**Correspondence Between
Staff and Applicant
Approval Letter**

Re: 5-PP-2017
Lomas Verdes Estates

The following is the responses to the 3rd review comments.

NATURAL AREA OPEN SPACE PLAN

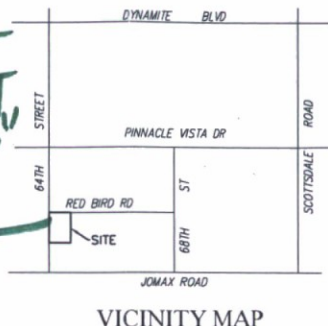
- a. The zoning ordinance requires the dedication of Natural Area Open Space (NAOS) in high priority areas, as per the ESL ordinance. The zoning ordinance requires the minimum NAOS width to be thirty (30 ft.) feet. Please update the project preliminary plat to identify a minimum 30-foot NAOS width provided by each proposed parcel (Zoning Ordinance Section 6.1060.F). Each parcel shall provide a minimum 30-foot NAOS width. Staff has highlighted those areas on the NAOS plan that still do not meet this ordinance (See Attachment "B").

IDEAS THAT DO NOT MEET THE MIN. '30' WIDTH FOR EACH PARCEL

1.
 - a. NAOS has been modified and corrected as requested.
 - b. There are no site walls with the exception of the monument signs at the entrance.
 - c. Tracts will not be proposed for NAOS. If used, Tracts would adversely impact the setbacks and deem this project undevelopable for this zoning.
